Product / Process Change Notification (PCN)

PCN Number: PCN_WPME-FDSM_173951275_20250120

Affected Series: WPME-FDSM

Affected Part Number: 173951275

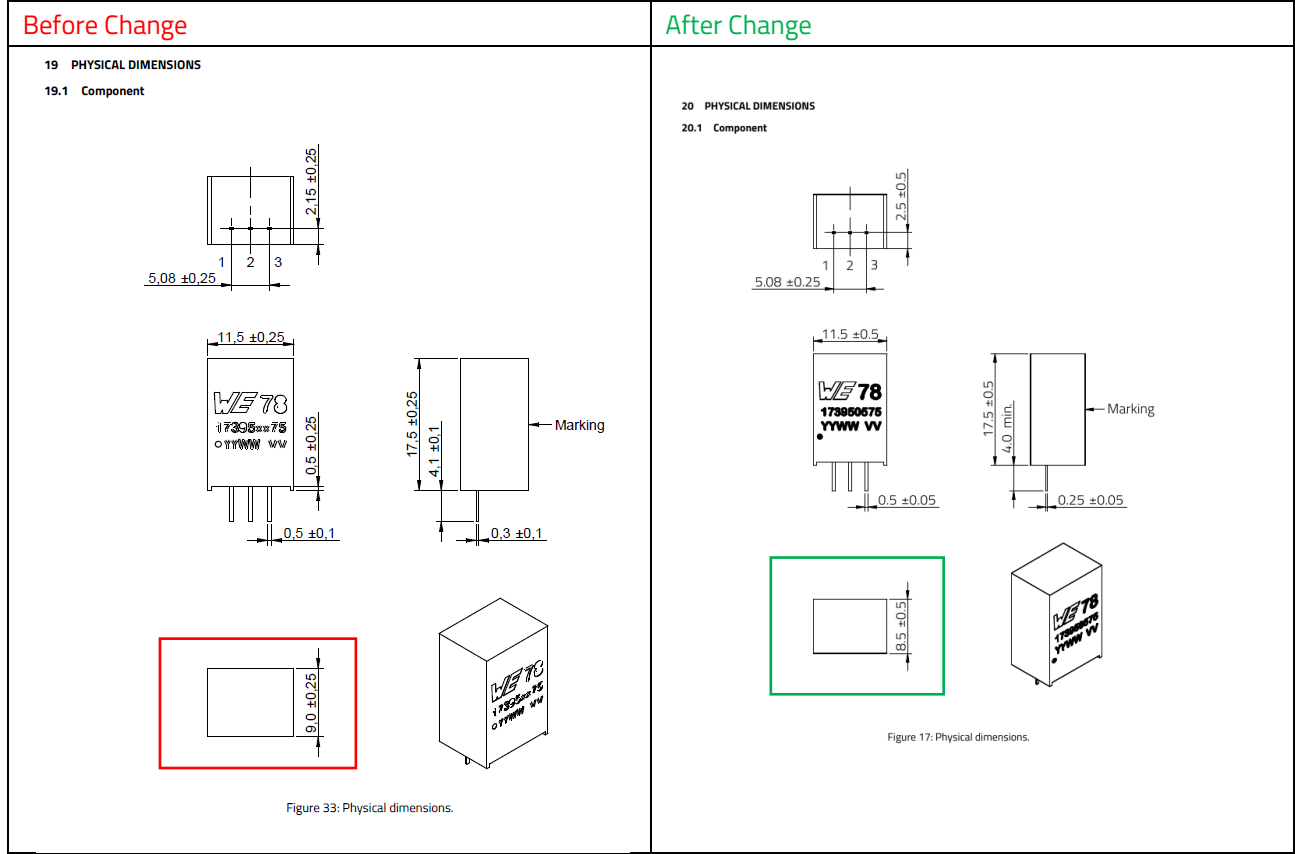
The diagrams shown in chapter TYPICAL PERFORMANCE CURVES are updated based on new electrical specifications. The used test conditions stay the same as before.

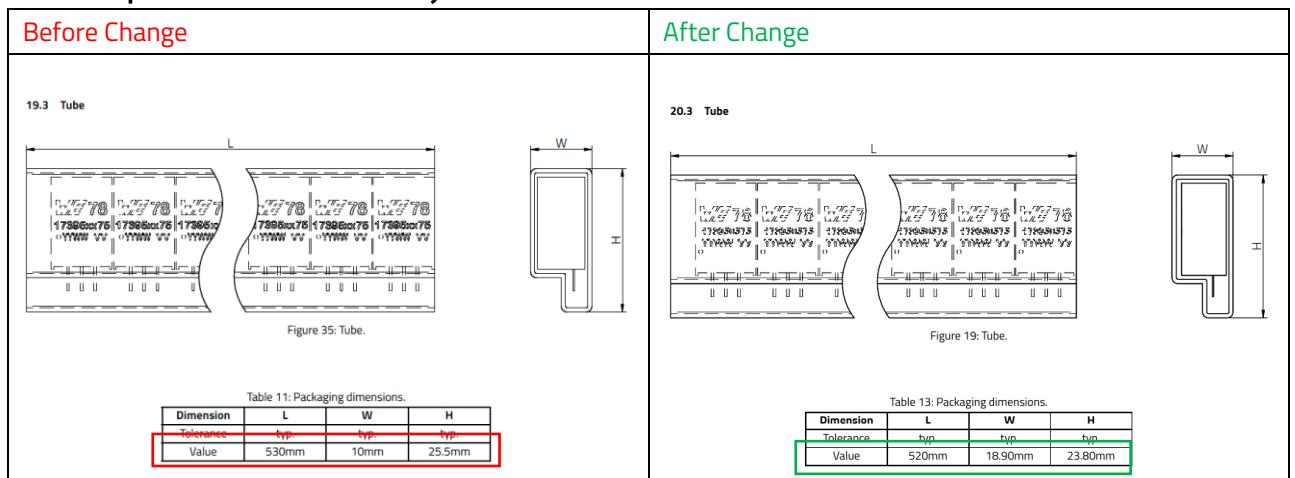
The mechanical dimensions have been updated based on new production. The SIP-3 package shape stays the same but with slightly deviated package width and adjusted tolerances.
